**STATE OF NEW MEXICO**  
**OFFICE OF THE STATE ENGINEER**  
**Santa Fe**

**Re: Lincoln Hills subdivision and golf course**

**MEMORANDUM**  
**OFFICE OF THE STATE ENGINEER**  
*Hydrology Bureau*

**SUBJECT:** Proposed Lincoln Hills Subdivision near Alto, Lincoln County; Evaluation of 40-year water supply from Wells H-694 and H-694-S

LINCOLN HILLS  
Site Layout with Pond Areas

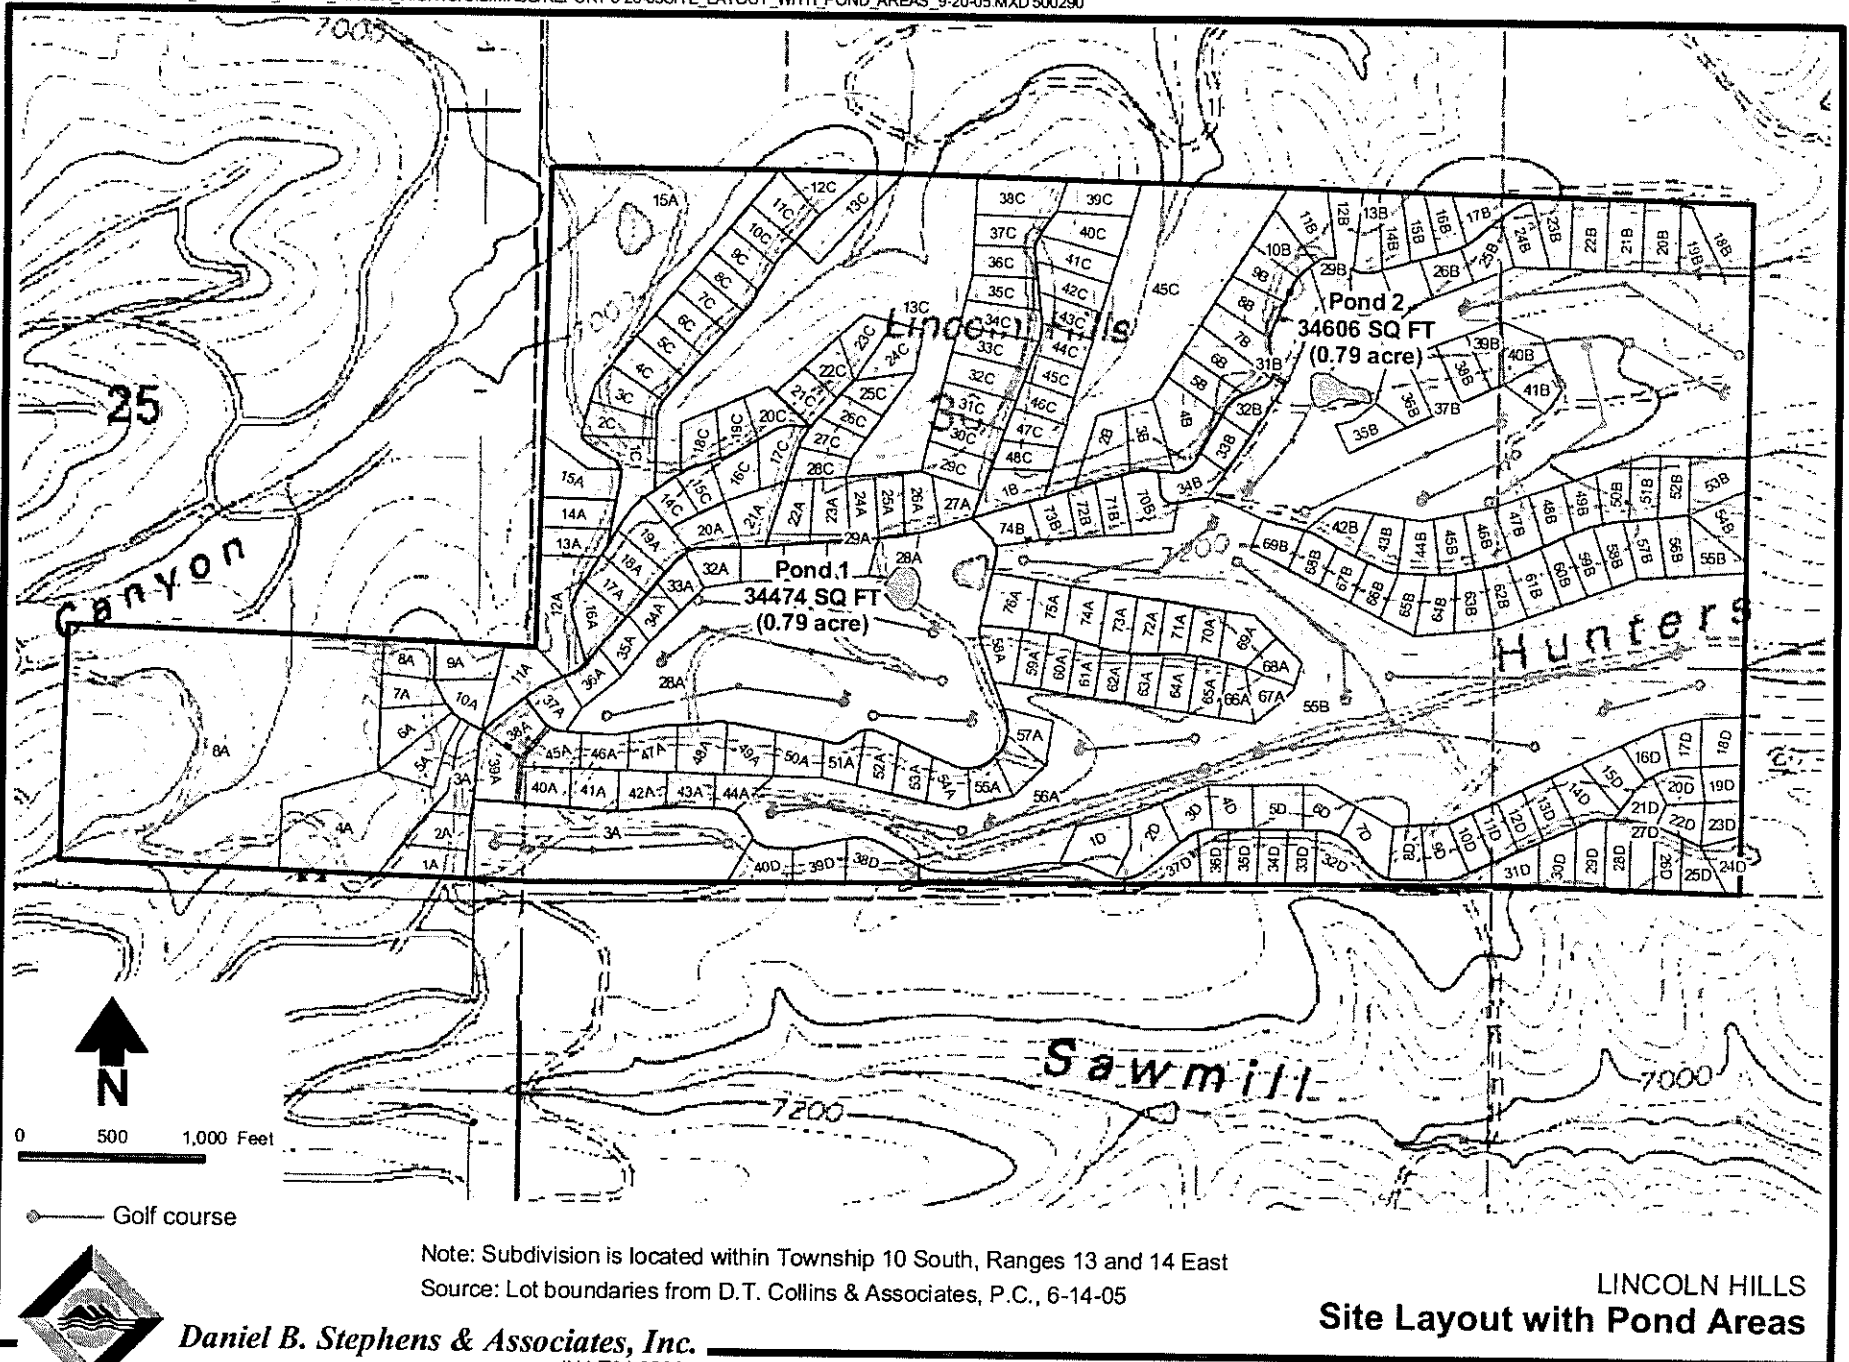
- Page 13 of the geohydrological analysis states that the golf course irrigated acreage is 45.4, while page 3 of the developer's Disclosure Statement states that the golf course acreage is 224.714.
- The proposal is silent on the surface area (and associated evaporative losses) of any man-made water features associated with the golf course.
- Page 13 of the geohydrological analysis states that a clubhouse is not planned for the golf course and that golfers will use a nearby non-Lincoln Hills facility, while page 5 of the document entitled "*Domestic Water Demands, Water Distribution System and Water Quality Information, June 2005*" specifies that the subdivision well is located near the proposed clubhouse.

1. The golf course will include two (2) lined ponds with a surface area of 0.79 acres each. The evaporative losses would amount to 1.975 acre-feet per year (see Attachment 2 and 3).

The attached figure shows the locations and acreage of the 2 lined ponds that will be used as part of the Lincoln Hills golf course irrigation system (each pond is 0.79 acres). A letter is forthcoming from the developer (Hunters Draw LLC) that there will be no other surface water hazards or features associated with the course. Note on the figure that there are 2 additional light blue areas present on the topo map background – these are drainage depressions and not ponds that are part of the proposed subdivision.

$(15 \text{ in/yr}) \times (1 \text{ ft} / 12 \text{ in}) \times (0.79 \text{ ac} \times 2 \text{ ponds}) = 1.975 \text{ ac-ft/yr} = \text{net depletion due to 2 ponds. This is equal to } 1.22 \text{ gpm. If } 20 \text{ in/yr is used, the net depletion would be } 2.63 \text{ ac-ft/yr (1.63 gpm).}$
